Mission Valley Community Plan Update Final Program Environmental Impact Report Errata

Project No. 518009 SCH No. 2017071066 August 16, 2019

Figure 3.3-3: Proposed Zoning

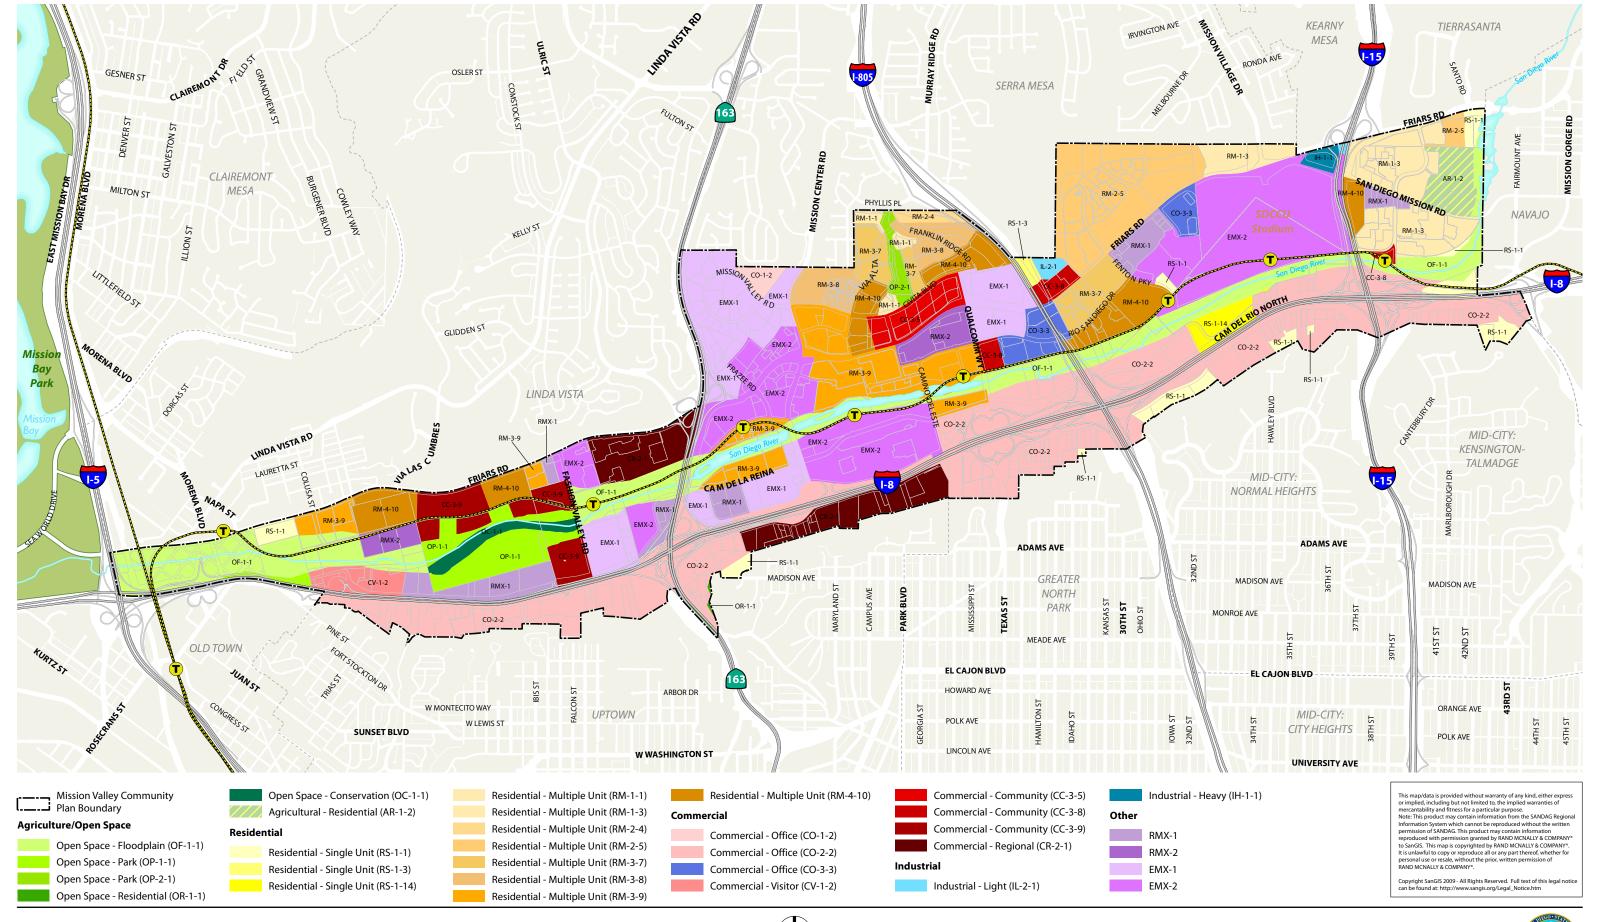
9. Figure 3.3-3, Proposed Zoning, is revised as follows:

Figure 4.11-3: Existing and Planned Park and Open Space Resources

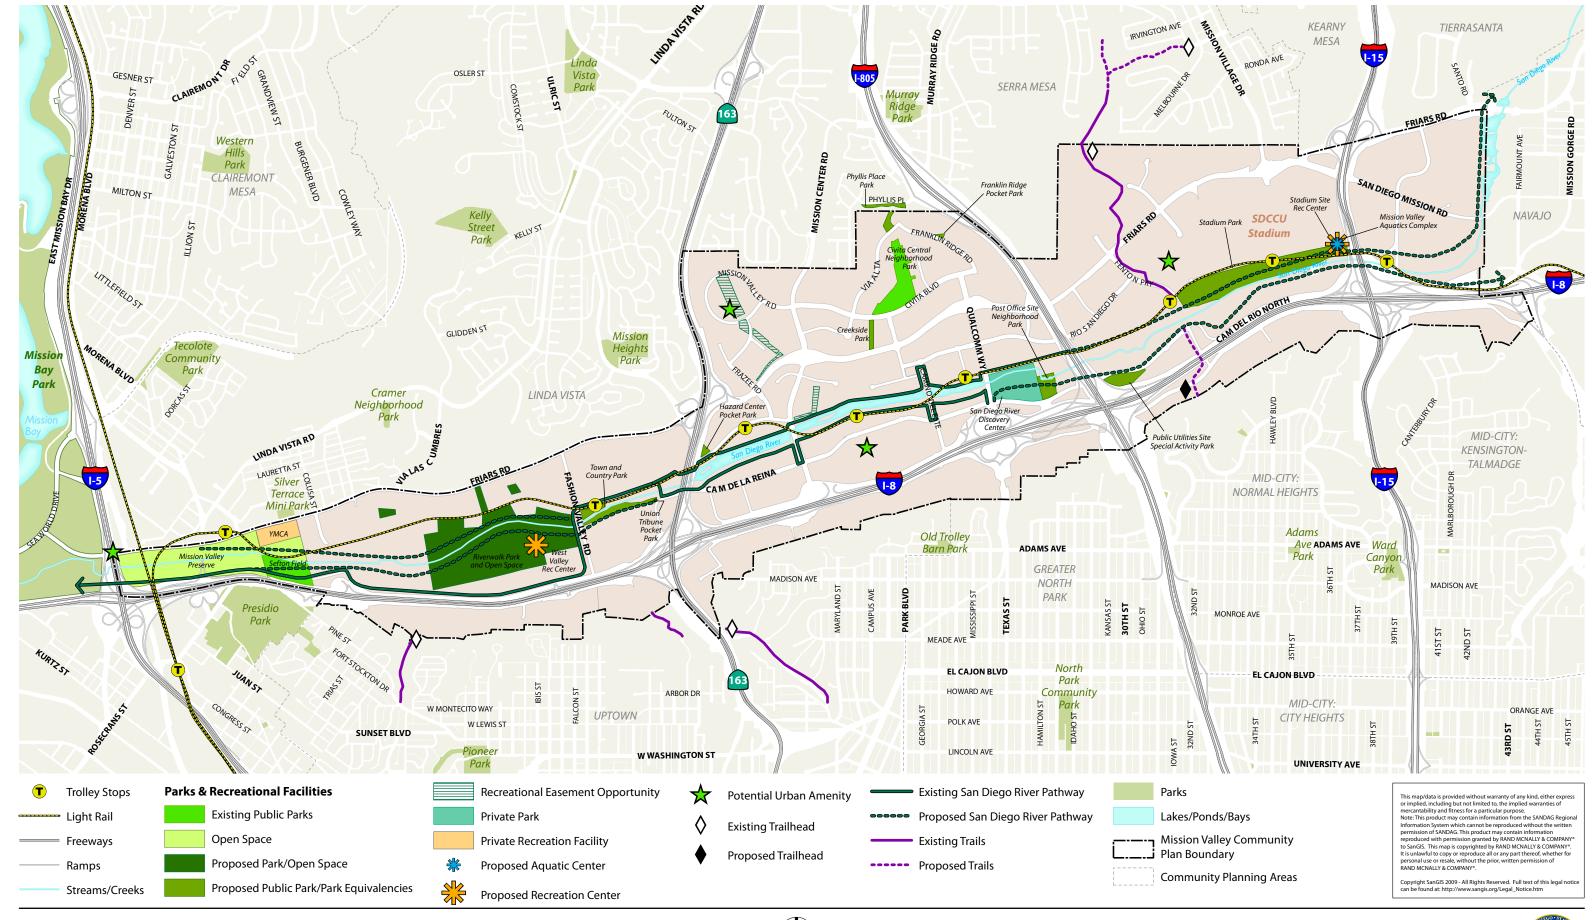
13. Figure 4.11-3, Existing and Planned Park and Open Space Resources, is revised as follows

Figure 4.13-6: Proposed CPU Pedestrian Route Types

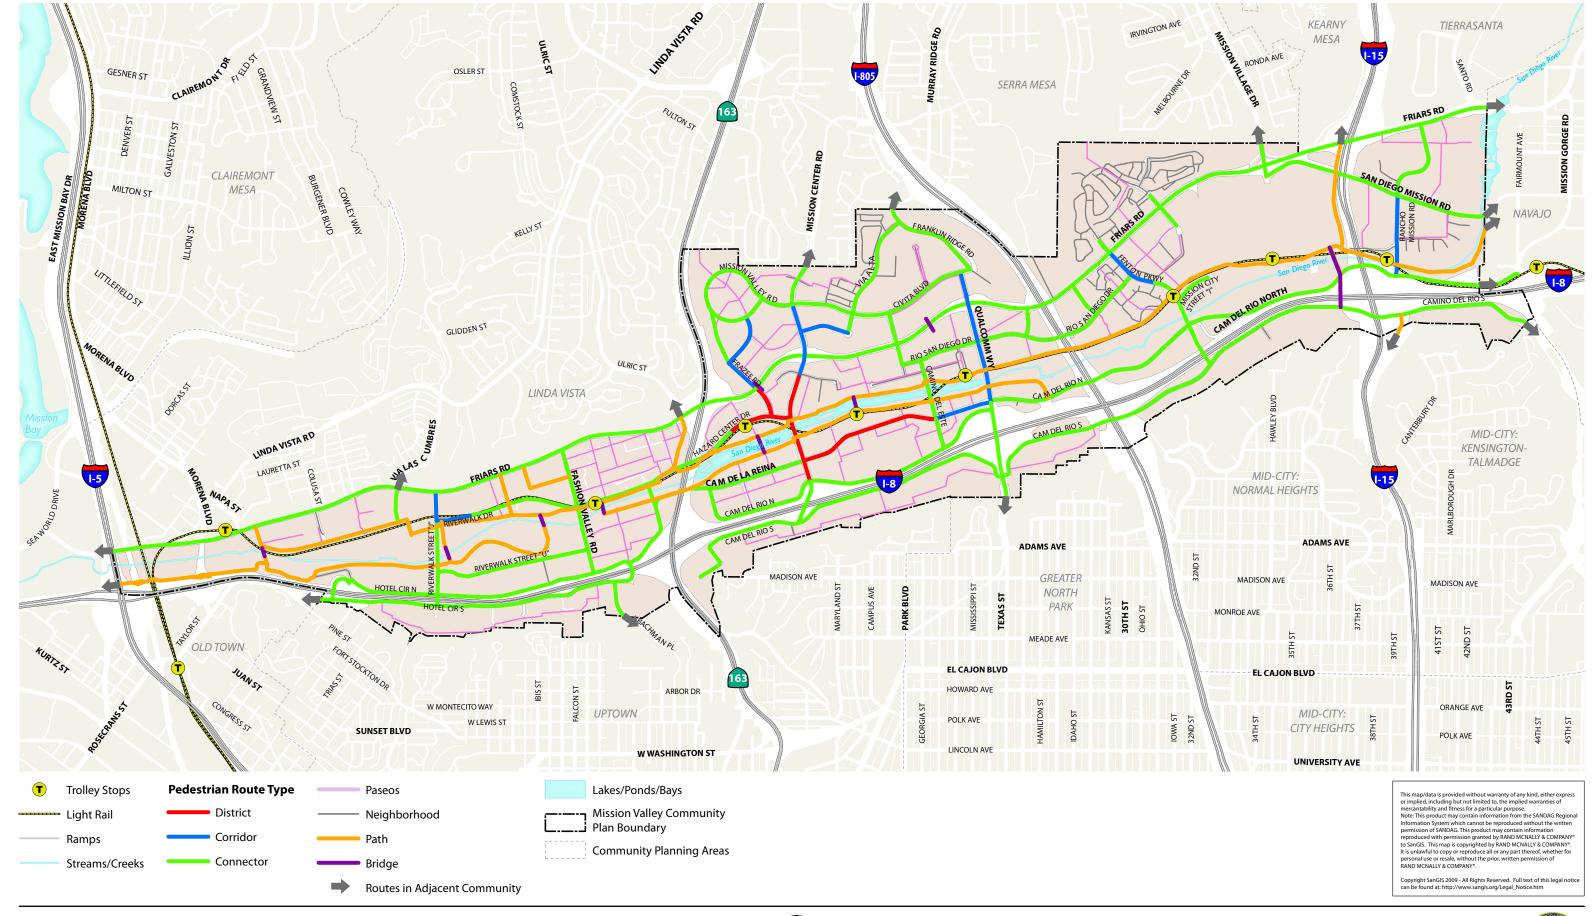
^{15.} Figure 4.13-6, Proposed CPU Pedestrian Route Types, is revised as follows:
